UNITED STATES PATENT AND TRADEMARK OFFICE

Office Action Summary

10/758,390

DETAILED ACTION

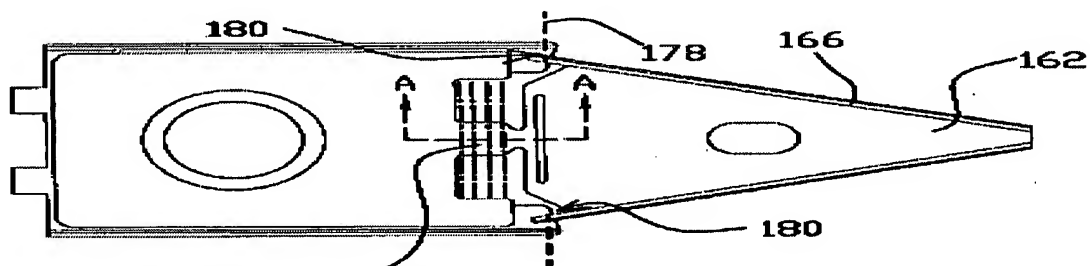
Regarding the argument that the aperture of Davis is not closed, the examiner respectfully disagrees. In figure 9B, the notch [164] and the pivot surface [170] meet upon the bending of the tether [174], therefore closing the aperture. This is supported in column 7, lines 21-42. Therefore, claim 1 is still met by Davis et al (US Patent Number 6778362). Claim 1 has been amended. Claims 12-20 have been canceled. Claims 21-29 have been added.

A mounting region (figure 9A, item 168);

A bend region adjacent the mounting region (figure 9B, item 178) comprising:

A bend member (figure 9B, item 180); and

A closed (column 7, lines 21-42) aperture bounded by the bend member and the mounting region (figure 9B below); and

A load beam region with a damping material support structure (figure 9A, items 174 & 176) adjacent the bend member (figure 9A), the damping material support structure offset from the bend member and extending into the aperture (figure 9A, items 174 & 176 are in the aperture).
